**EXHIBIT LIST FOR SUB 2020-007/EA 2020-023  
Preliminary Plat of Country Acres**

RE: GEOTECHNICAL REPORT ADDENDUM NO. 1; COUNTRY ACRES RESIDENTIAL DEVELOPMENT, BENTON COUNTY, WASHINGTON

### STAFF REPORT TO THE BENTON COUNTY PLANNING COMMISSION

DWG. No.  
**PP01**

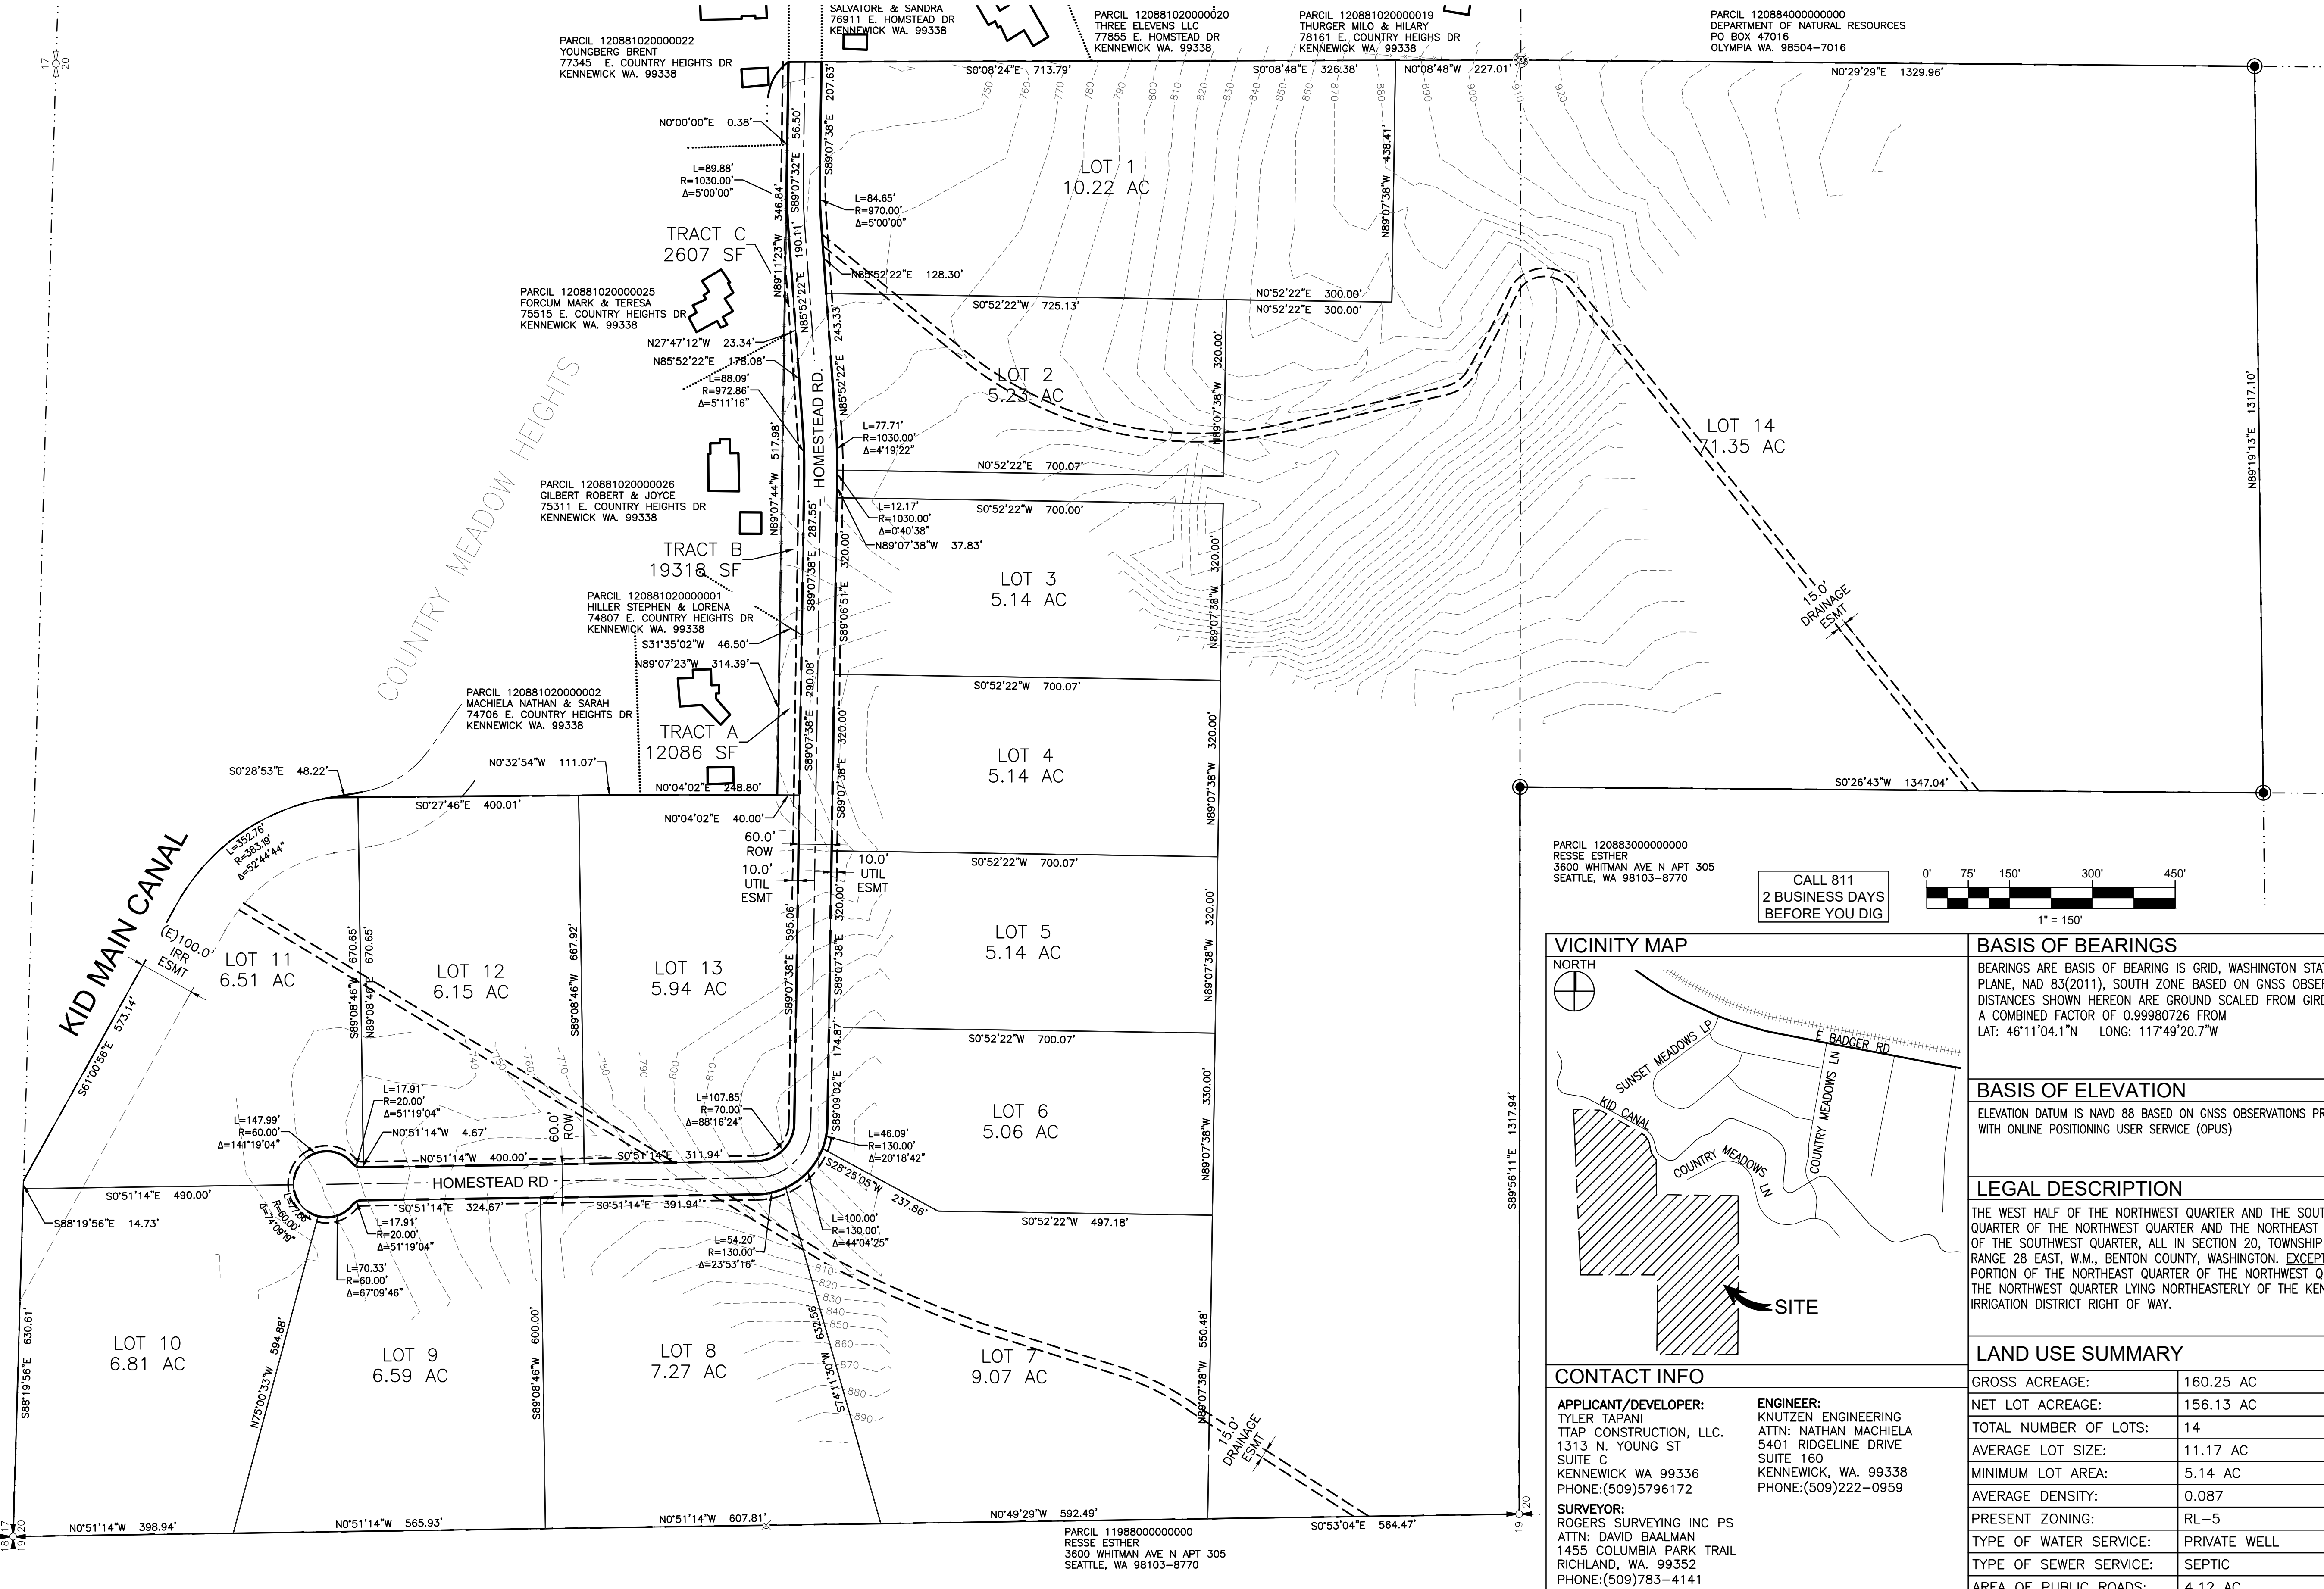
1. The proposed subdivision (PCM 1.4, application and PCM 1.5, preliminary plat map) conforms to the Benton County Comprehensive Plan, any applicable zoning requirements and other applicable land use controls;

2. There exists KID/United States Bureau of Reclamation (USBR) Right-of-Way
  - a. (ROW) along the northern property line. The Applicant must show this ROW on the preliminary plat. A copy of the ROW maps are available upon request. The proximity of the proposed residential development to the KID ROW increases the risk of harm to KID facilities and exposes residents to risk of injury. In order to mitigate these risks, the KID requires the following:

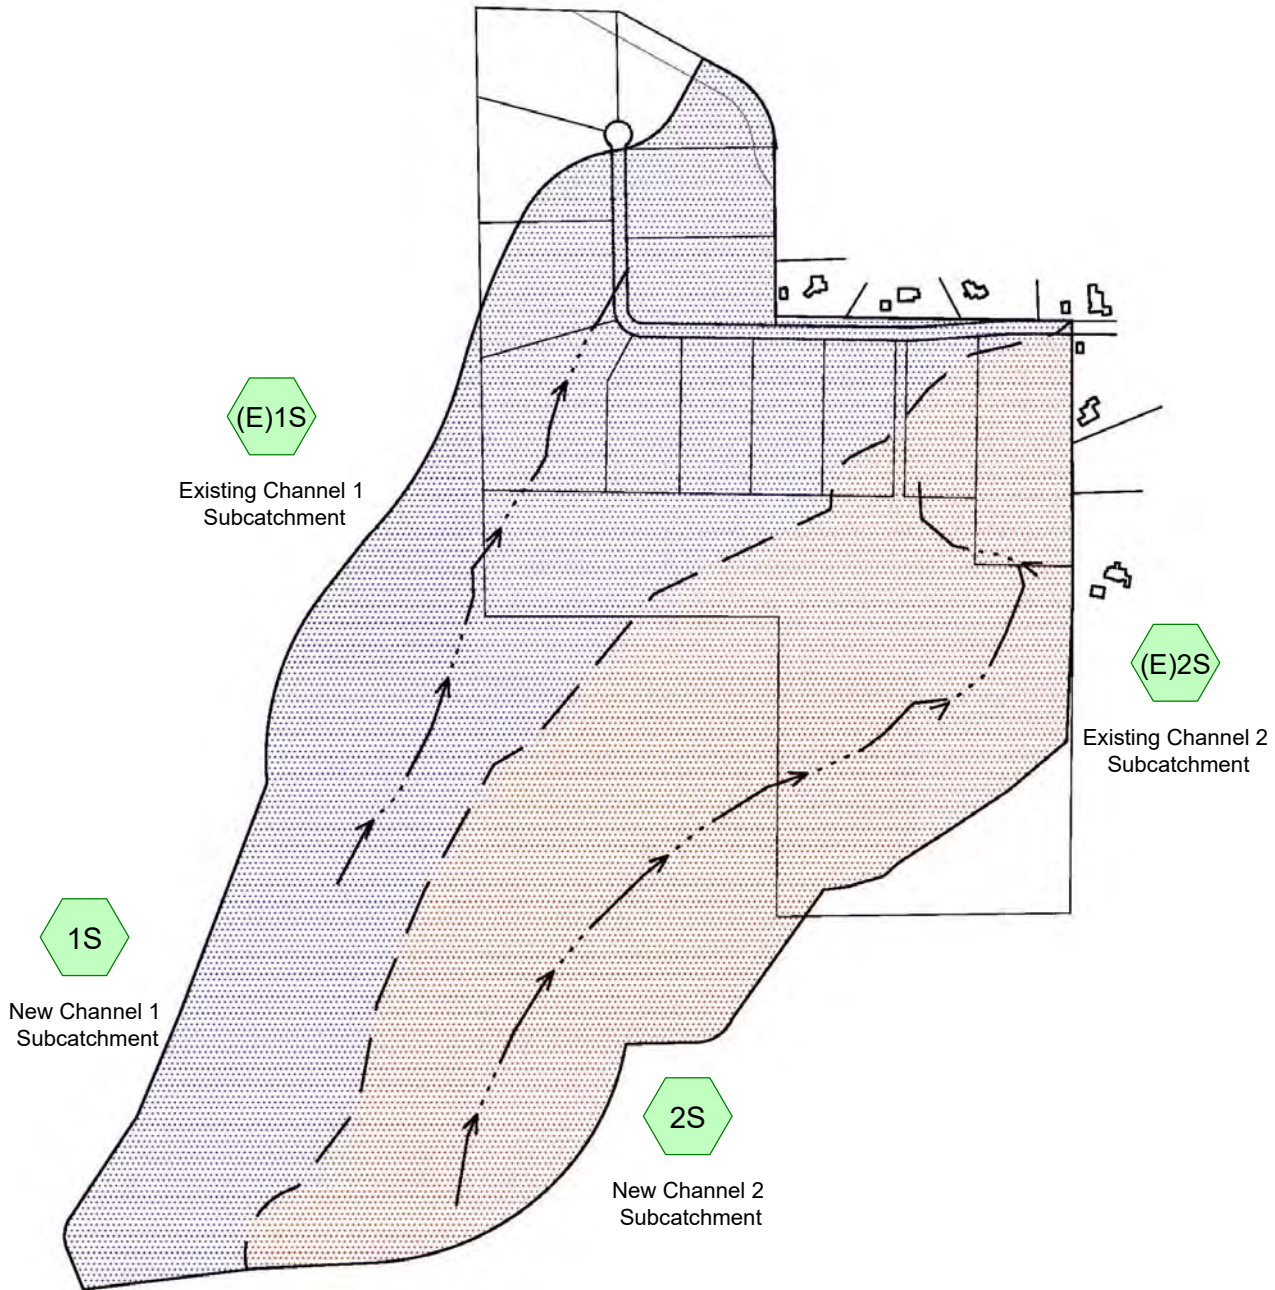
Question 3: What is the “Ultimate State” highwater zone in or along the channels and ponding areas for the 100 year return period precipitation runoff using runoff co-efficients representative of the condition when development is 100% complete.

*Response: Channel 1’s and channel 2’s post-development subcatchment areas produce the same amount of runoff as their “natural states”. The runoff depths also remained the same at 0.18 in. It is therefore assumed that proposed impervious surfaces will not have a significant effect on the natural channels and their abilities to contain and infiltrate the site’s stormwater runoff. The preliminary plat for the project proposes drainage easements along the natural channels to preserve the natural conveyance and infiltration system.*
